# COMPLETE MONOGRAPH

## **2022 GROUP B PROPOSED CHANGES TO THE I-CODES ROCHESTER COMMITTEE ACTION HEARINGS**

2021-2022 Code Development Cycle, Group B (2022) Proposed Changes to the 2021 *International Codes*

FIGURE R301.2.1.1 REGIONS WHERE WIND DESIGN IS REQUIRED

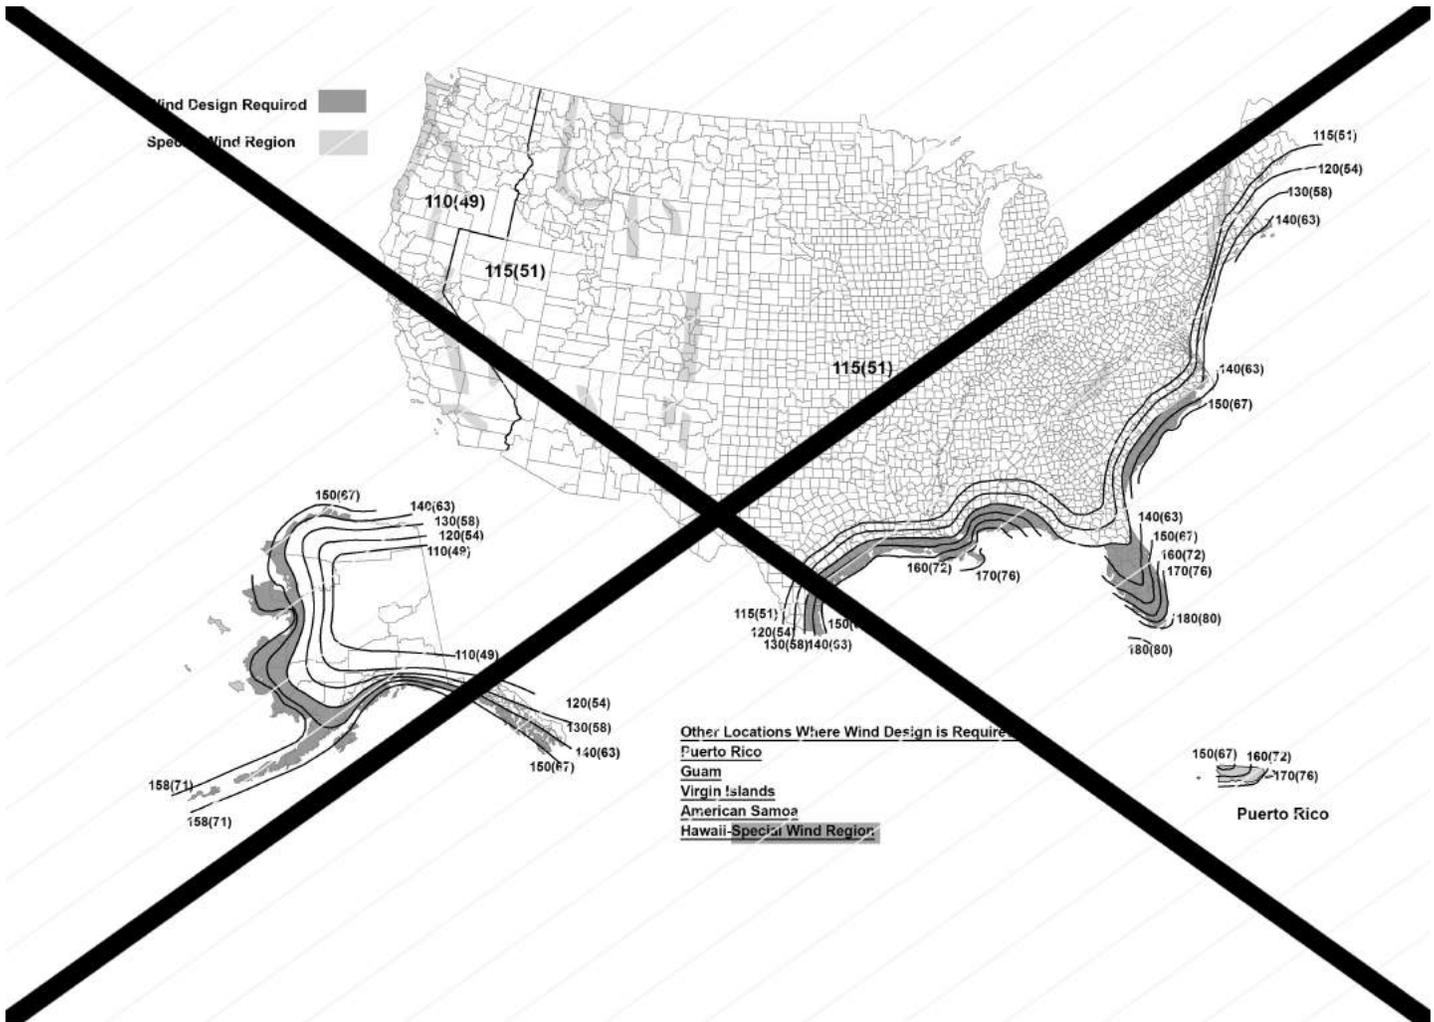
Delete and substitute as follows:

**FIGURE R704.2.1(1) TYPICAL SINGLE-SPAN VINYL SOFFIT PANEL SUPPORT**

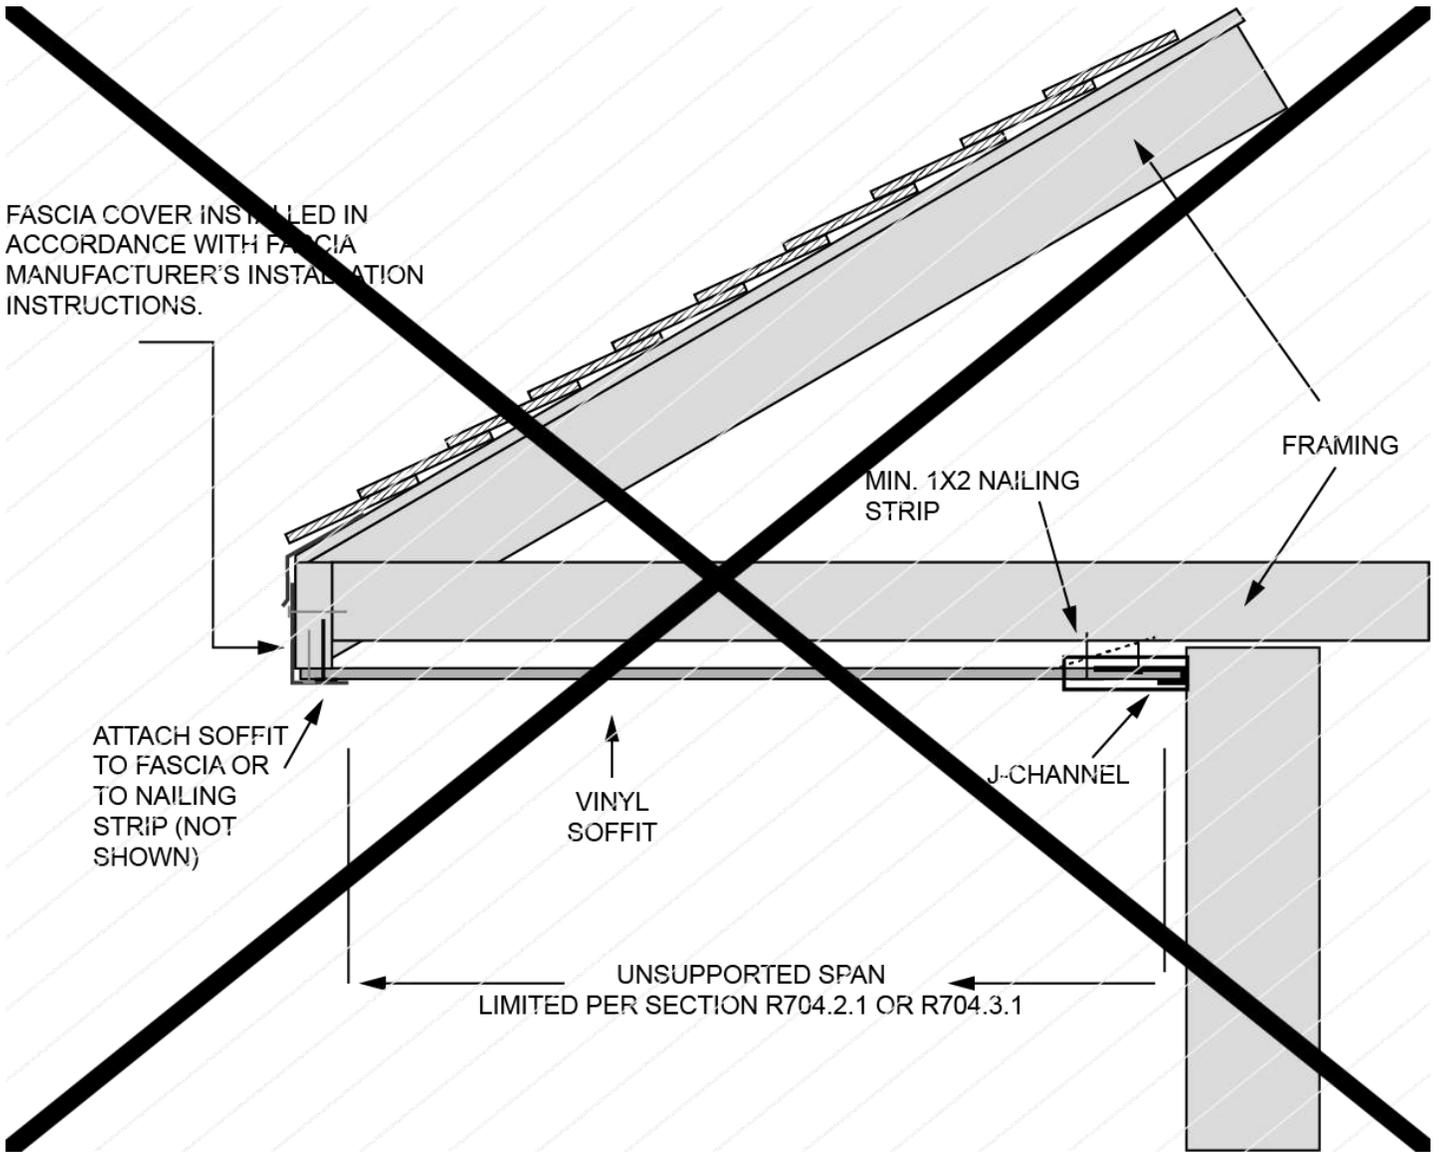
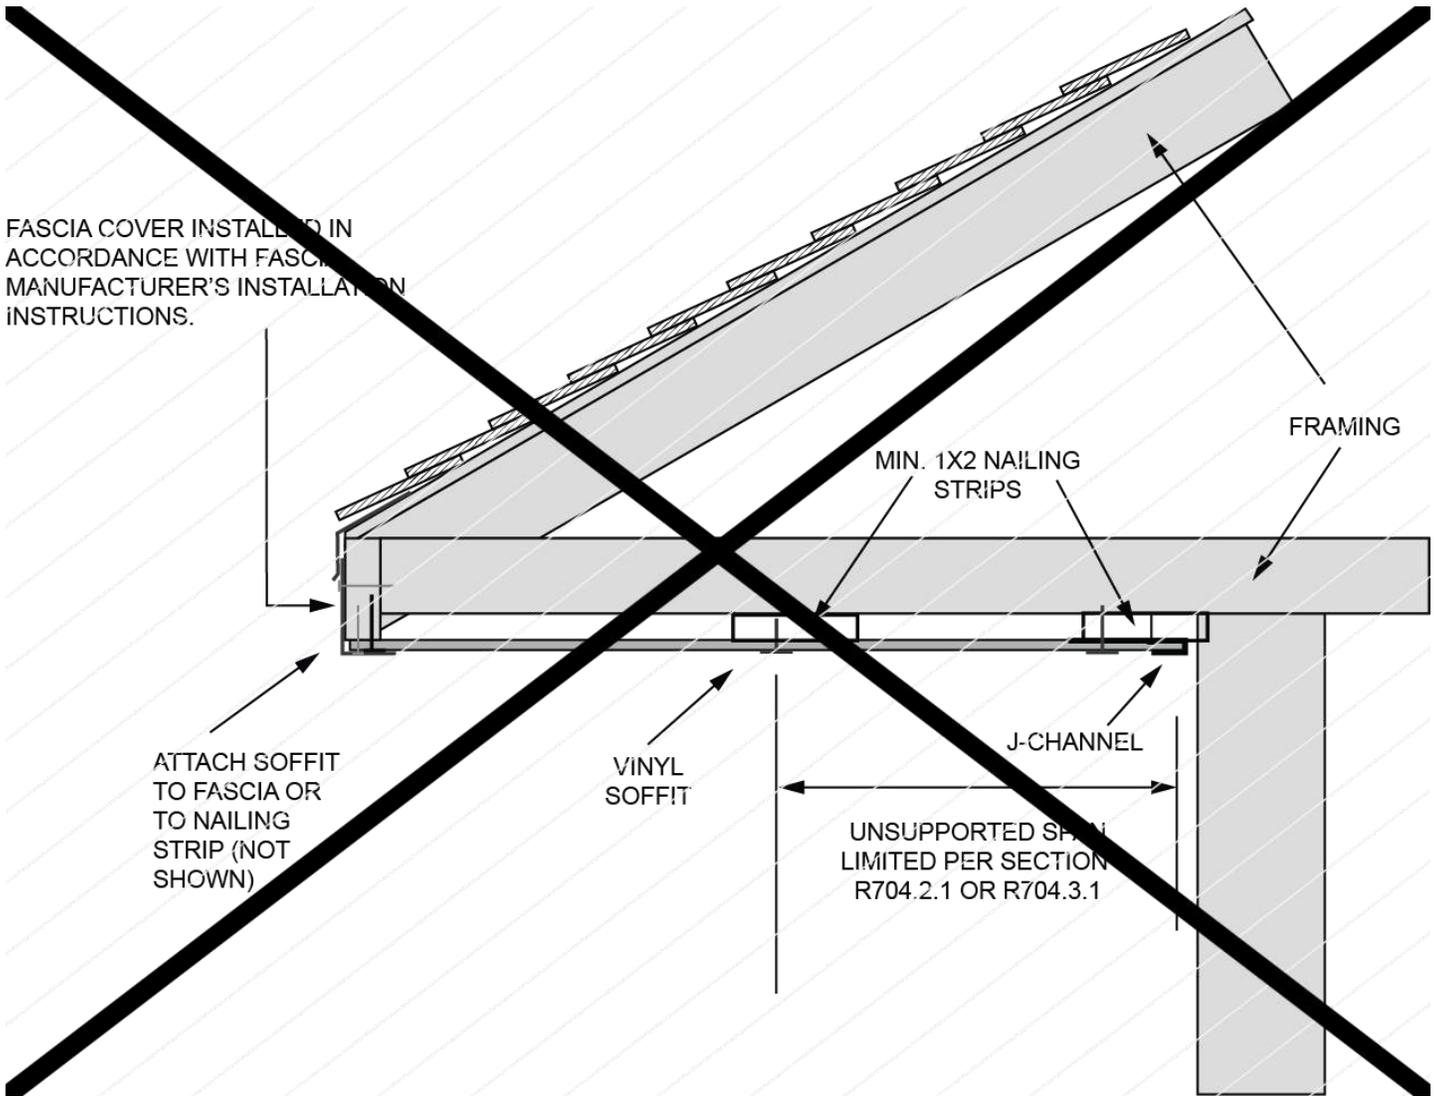
**Proponents:** Matthew Dobson, representing Vinyl Siding Institute (mdobson@vinylsiding.org); T. Eric Stafford, representing Insurance Institute for Business and Home Safety (testafford@charter.net)
